Technical Service Bulletin

Topic	PSIS 750600B0001 Seat belt pre-tensioner buckle switches - Harness modification
Market area	Bentley: worldwide (2WBE)
Brand	Bentley
Transaction No.	2037995/5
Level	EH
Status	Released for publishing
Release date	Sep 19, 2022

Wiring modification for seat belt pre-tensioner buckle switches

P.S.I.S. 750600B0001

Figure 1 Right-hand drive vehicles

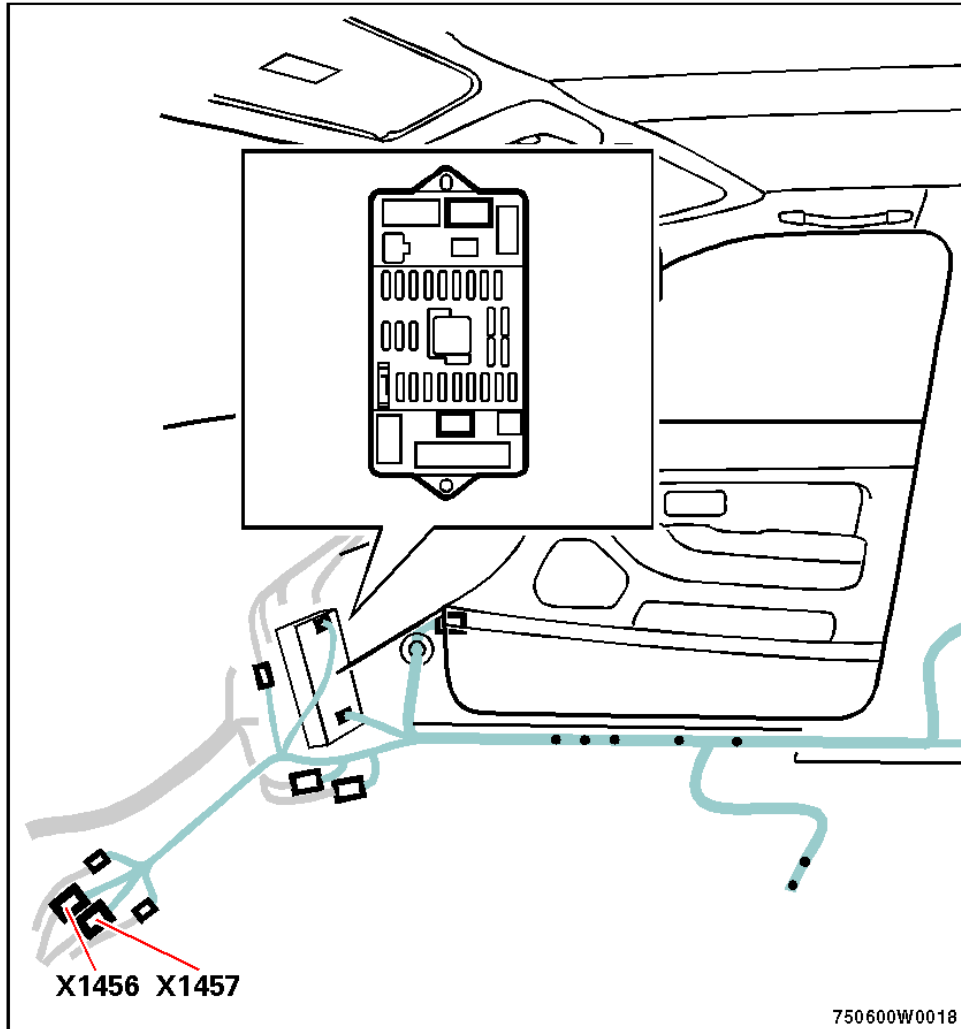
1. With reference to figure 1 identify connector X1457.

2. On the female side of this connector cut the yellow cable at cavity 1. The cut should be made approximately 2 inches (50 mm) from the terminal. Strip back the insulation on each side of the cut and fit a piece of heat shrink.

3. Splice and solder together the two yellow cables from the link looms and the two yellow cables stripped at connector X1457. This splice should have two cables on each side of it.

Figure 2 Left-hand drive vehicles

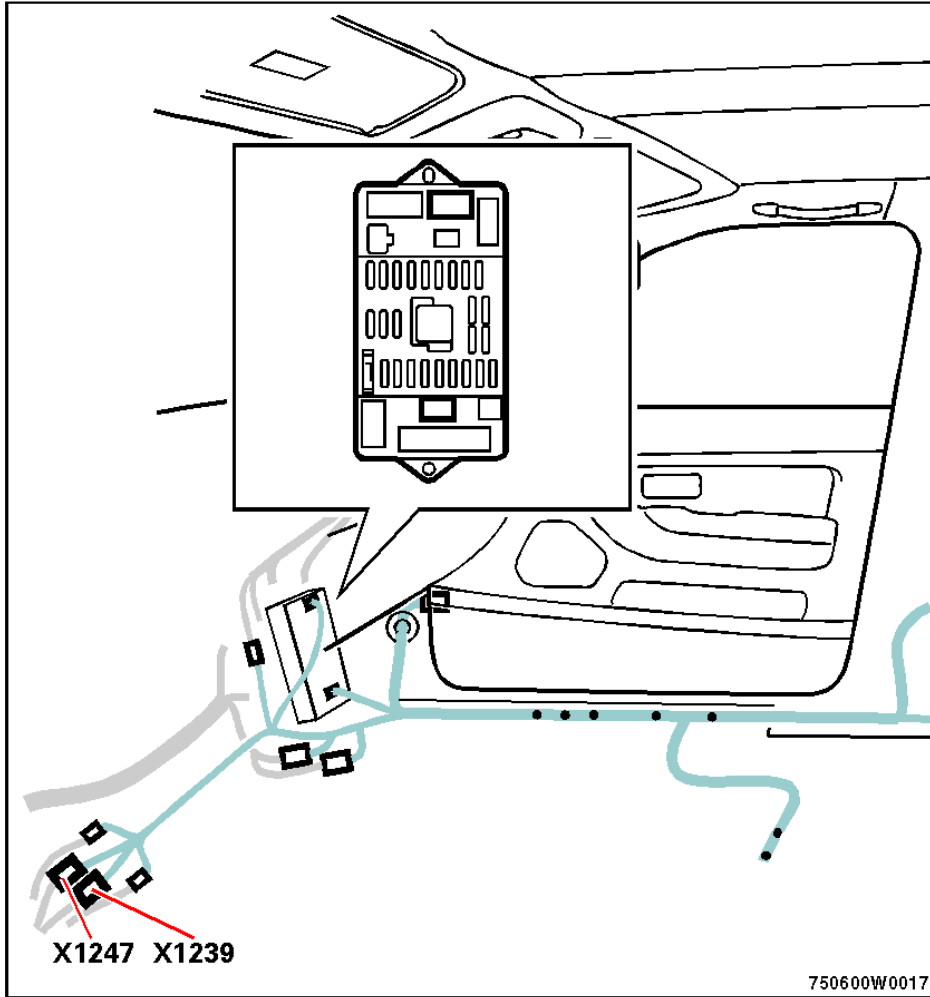
1. With reference to figure 2 identify connector X1239.

2. On the female side of this connector cut the yellow cable at cavity 1. The cut should be made approximately 2 inches (50 mm) from the terminal. Strip back the insulation on each side of the cut. Apply a piece of heat shrink to one of the cables.

3. Splice and then solder together the two yellow cables from the link looms and the two yellow cables stripped at connector X 1239. The splice should have two cables on each side of it.

Wiring diagram

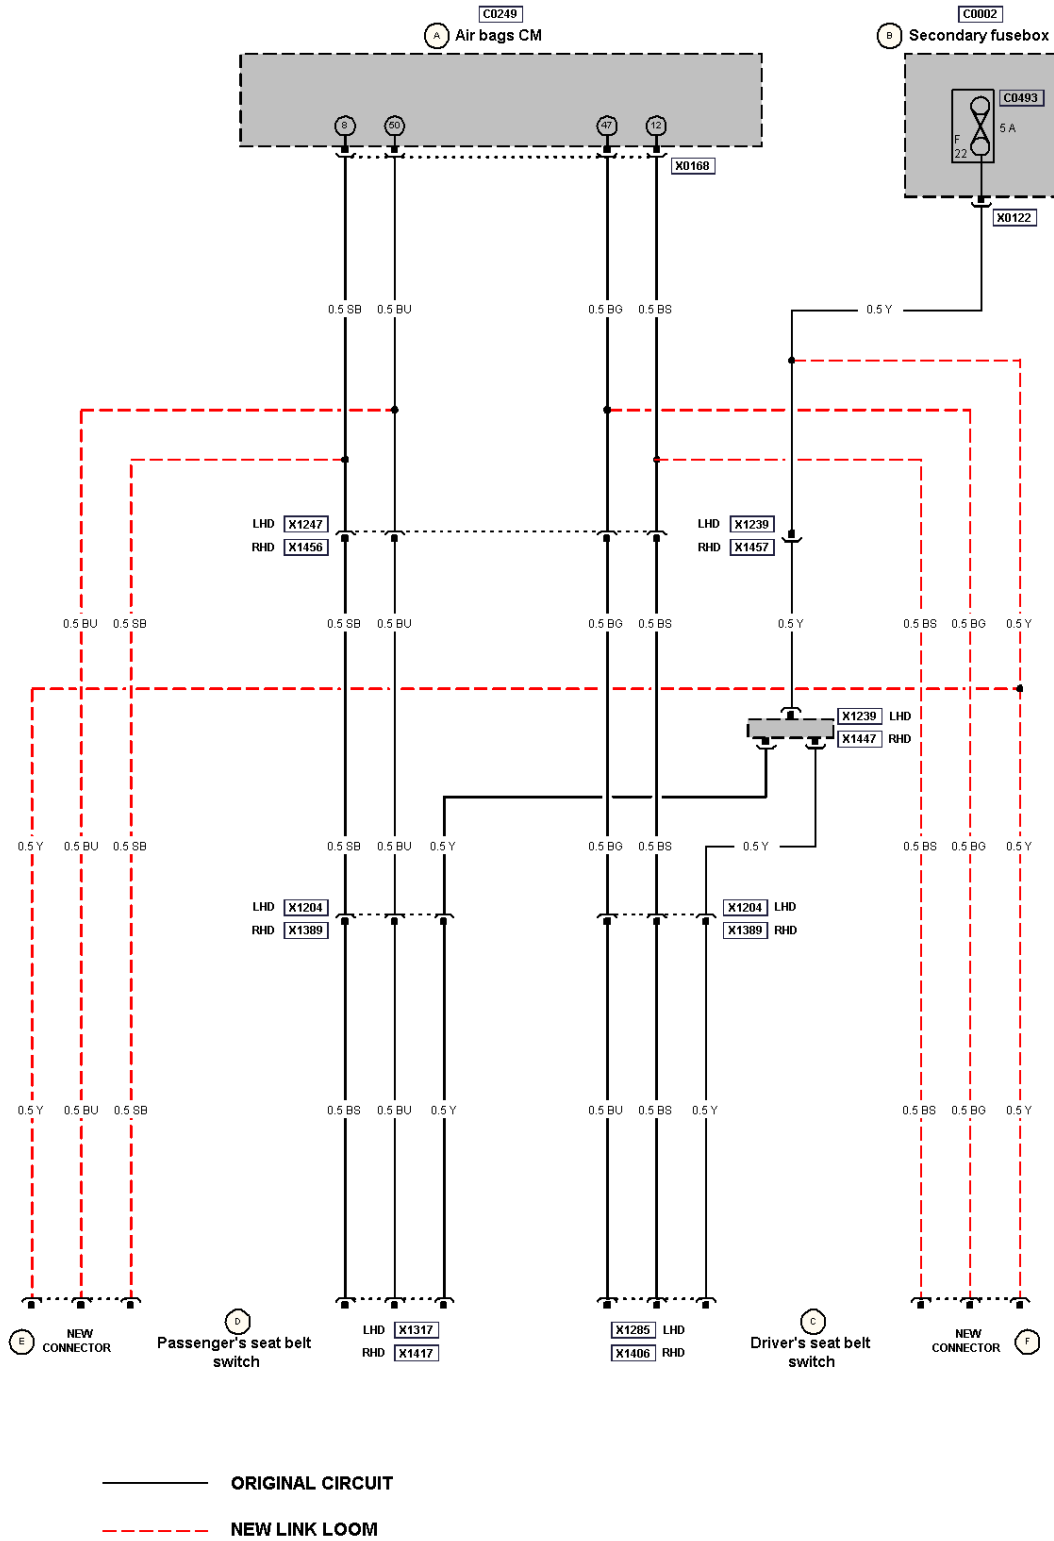
This modification involves the rewiring of the buckle switch circuit, so that these two connectors are not utilised. For clarification this procedure is broken down into two parts, right-hand drive vehicles and left-hand drive vehicles.
